ADDENDUM NO. 03

**Clark-Pleasant WCHS Phase 3
300 E Main St.
Whiteland, IN 46184**

**PROJECT: CLARK-PLEASANT COMMUNITY SCHOOL CORP.
WHITELAND COMM. HIGH SCHOOL ADDITION
PHASE 3**

DATE OF ADDENDUM: JULY 28, 2025

6 ENLARGED INT. ELEV. CORRIDOR N1000 - NORTH WEST
SCALE: 3/8" = 1'-0"

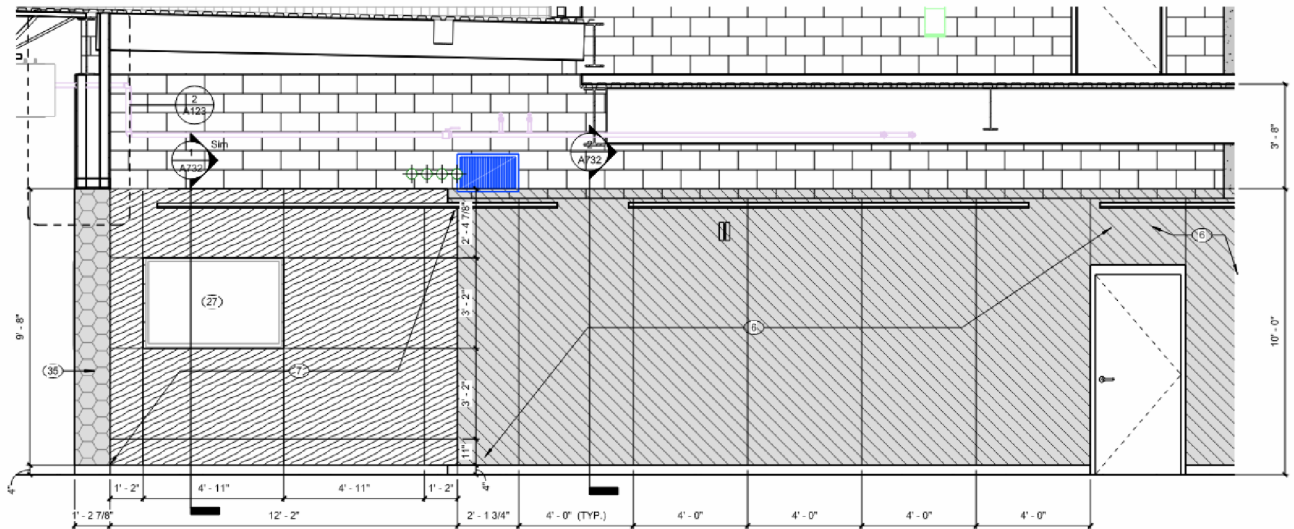
Q: On page A750, the elevations show a corridor with 189'-8" of graphic wall padding, with each pad measuring 4'-0" wide x 9'-8". First of all, we have never seen a padded corridor wall. Secondly, we can't manufacture a 9'-8" high pad. Our maximum is 48" x 96". If they want to keep this height, we'd have to make these pads in two pieces to achieve that height, thereby creating a horizontal line the full length. Having that many seams in a full length graphic would most likely disrupt the artistic intention. Is there a reason that a corridor will have a padded wall? If any one pad is ever damaged, the chances that the

colors will match are almost nil. The key "statistic", is that this many pads will cost over \$25,000.00, BEFORE graphics.

1. A: Corridor N1000 will NOT have soft wall padding. Instead, it will be a custom graphic laminate panel system. This system would be comprised of panels made from compact plastic laminate with custom printed graphics. Please see snips below and finish elevations/legend. Here is our basis of design: <https://panelspec.com/products/wall-panel-systems/custom-graphic-laminate/>

- 6 FULL WALL CUSTOM GRAPHIC WALL PROTECTION PANELS, WP-2. COORDINATE FINAL GRAPHIC DESIGN WITH OWNER. REFER TO DETAILS AND SPECS FOR PANEL INSTALL INFO

WP-2	MFG:	PANEL SPECIALISTS, INC
	TYPE:	HIGH PRESSURE WALL PROTECTION PANEL SYSTEM
	PRODUCT:	CUSTOM GRAPHIC IMAGE HIGH PRESSURE LAMINATE PANELS
	COLOR:	CUSTOM MURAL - DESIGN TO BE COORDINATED WITH OWNER
	LOCATION:	N1000 CORRIDOR
	REMARKS:	INSTALL PANELS WITH HAT CHANNEL OR Z-CLIPS PER MFG INSTRUCTION; <1/16" REVEAL FOR SEAMLESS OVERALL LOOK; INCLUDE TRIM PER MFG RECOMMENDATIONS
